Municipal Planning & Design Review Commission
Regular Meeting Agenda
Thursday, September 14, 2023, 5:30 PM
City Hall, Lakeland, Tennessee 38002

Project: Lakeland School System Administration Building - Site Plan

Project: Equestria PD Outline Plan

Site Details

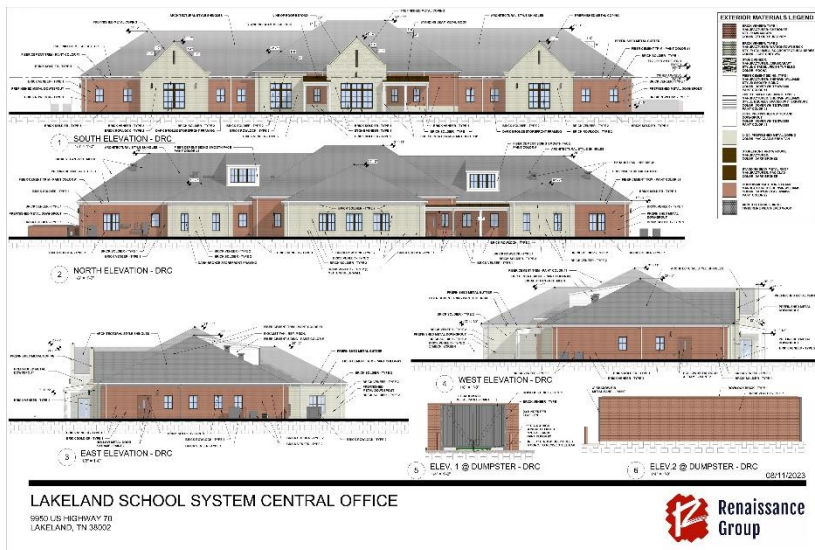
Access to the site will be from one twenty-six (26) foot wide ingress/egress point off of Highway 70. Parking is shown as eighty-two (82) overall spaces with four (4) handicapped spaces which is in line with the allowable spaces per the Land Development Regulations. All of the proposed parking is situated on the north, west and south sides of the building with the spaces on the south side used primarily as visitor parking and the spaces on the north side reserved for employees. The City of Lakeland Land Development Regulation require that all parking be located in the rear and sides of civic buildings. The current site configuration does not conform to this standard.

Final Plat

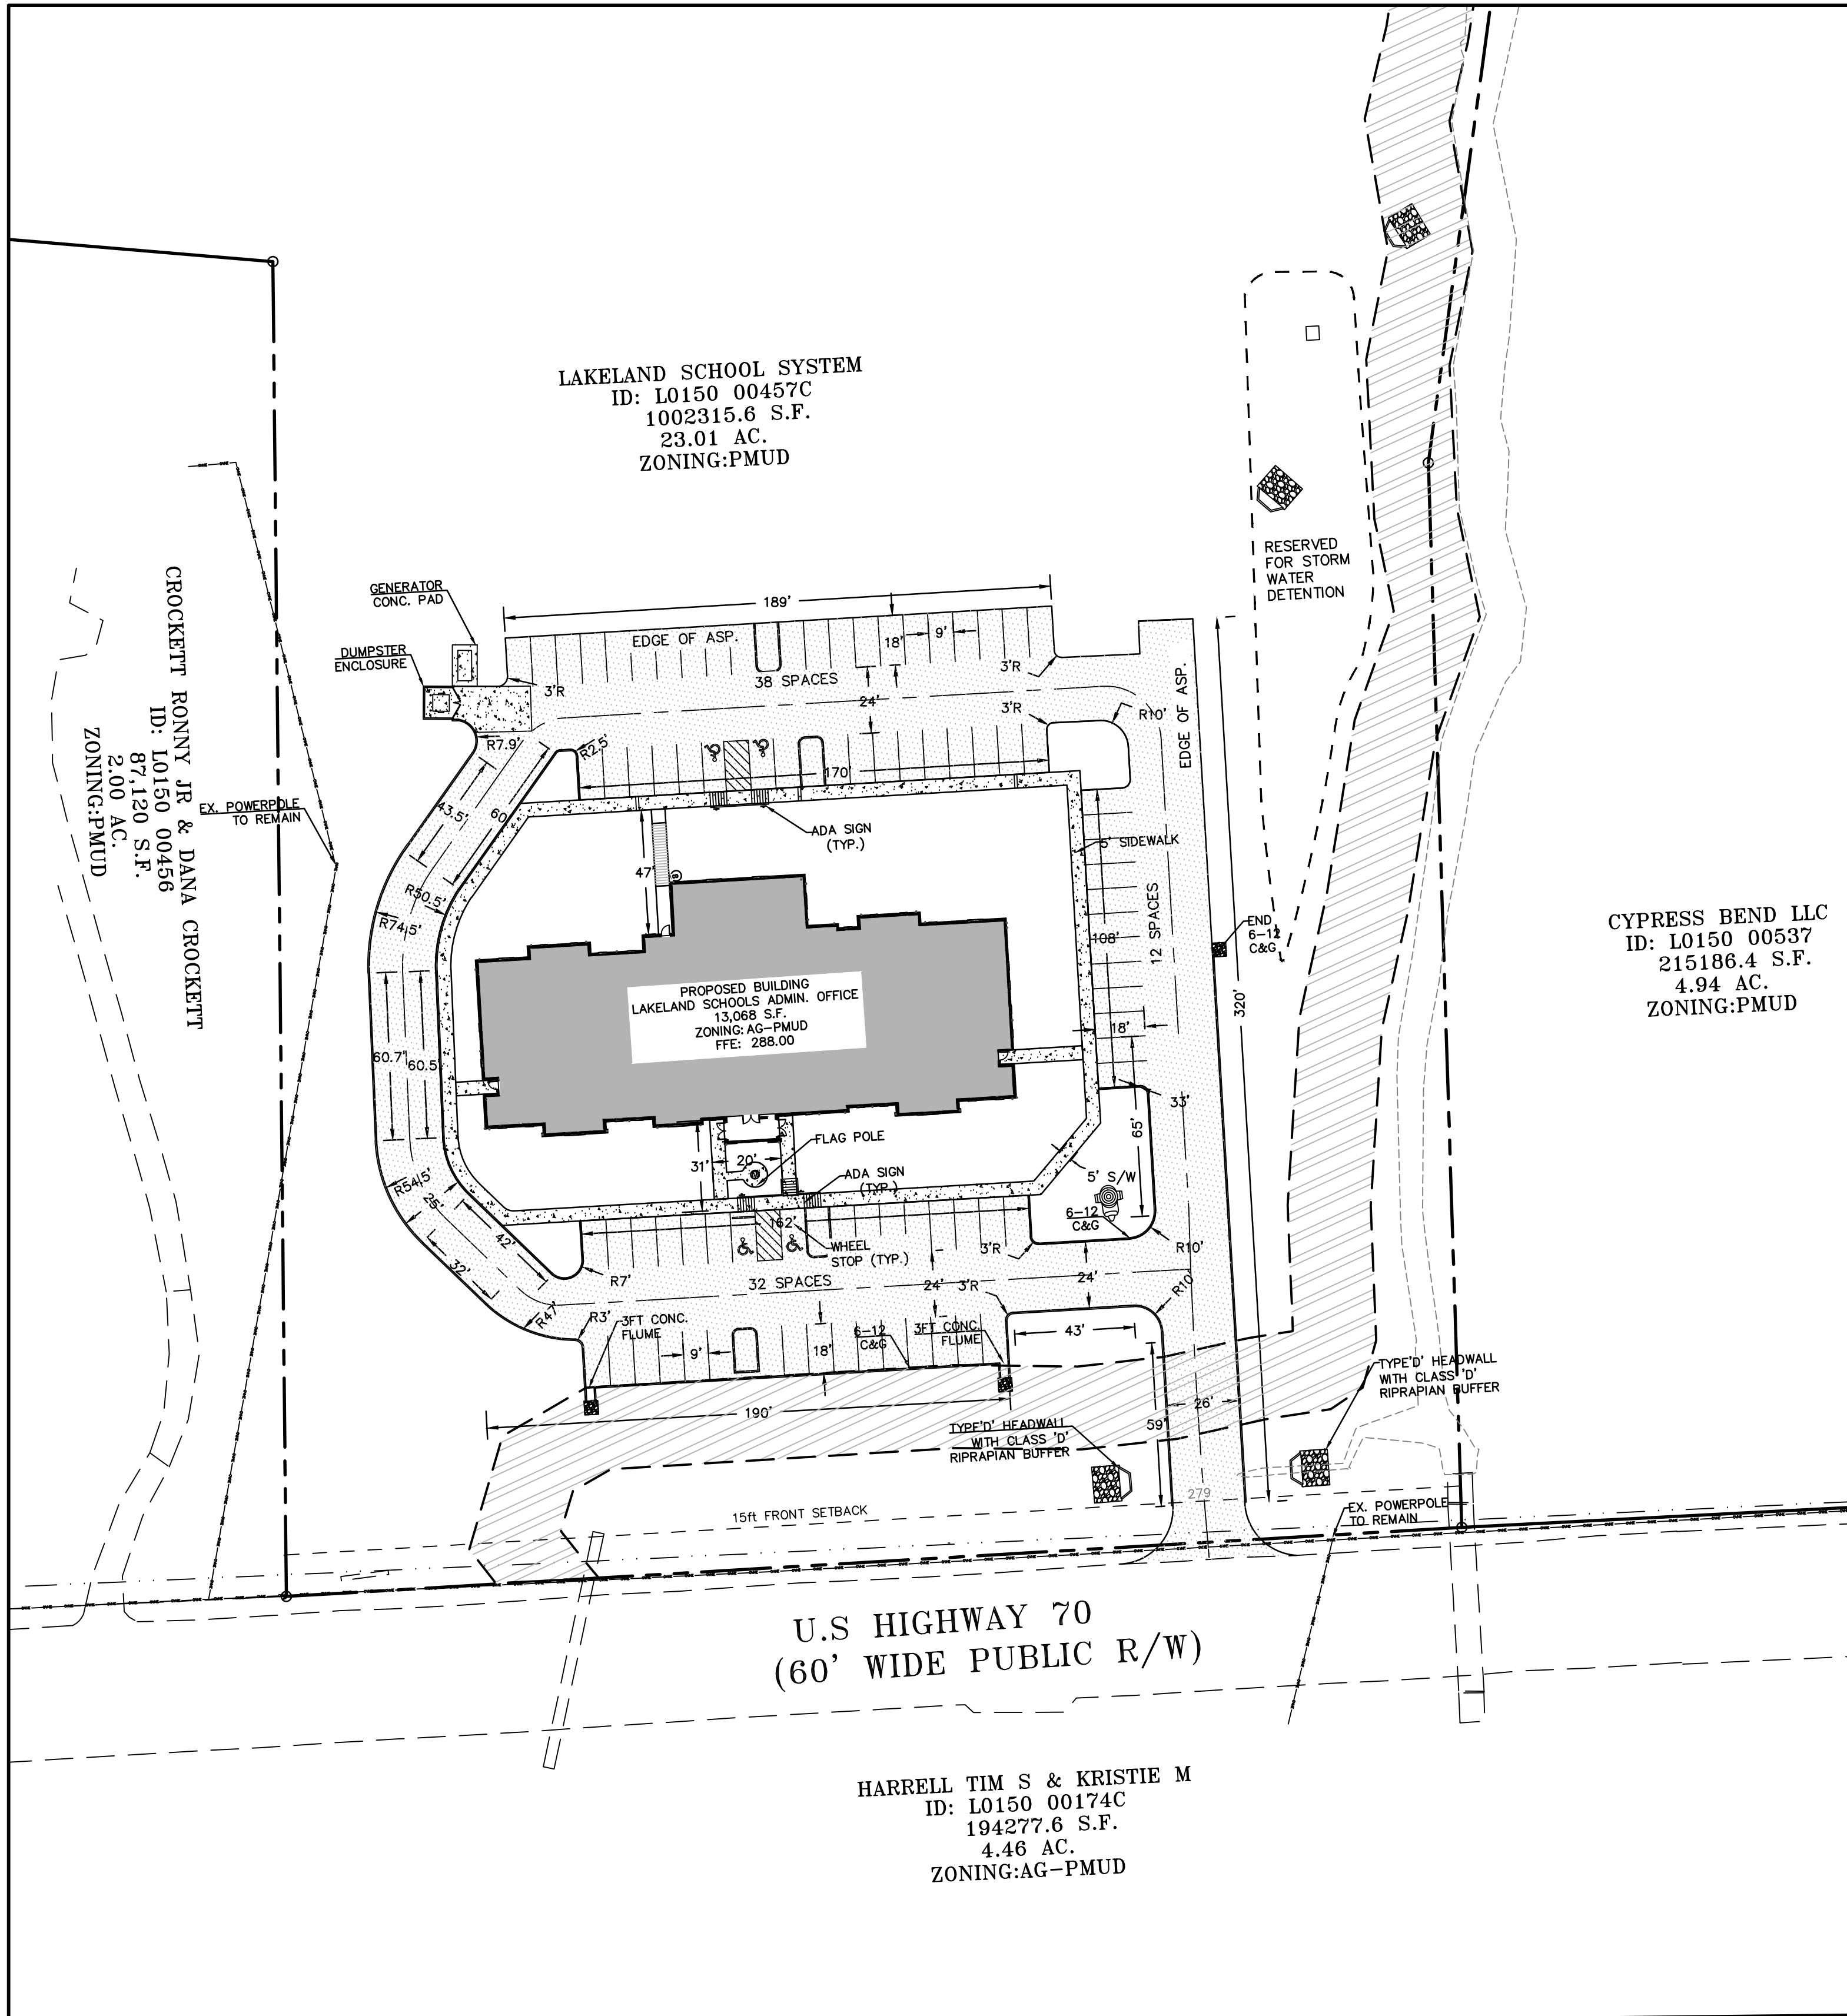
A Final Plat will need to be recorded to show the ROW dedication for Highway 70 as well as the stream buffer and private sewer easements proposed.
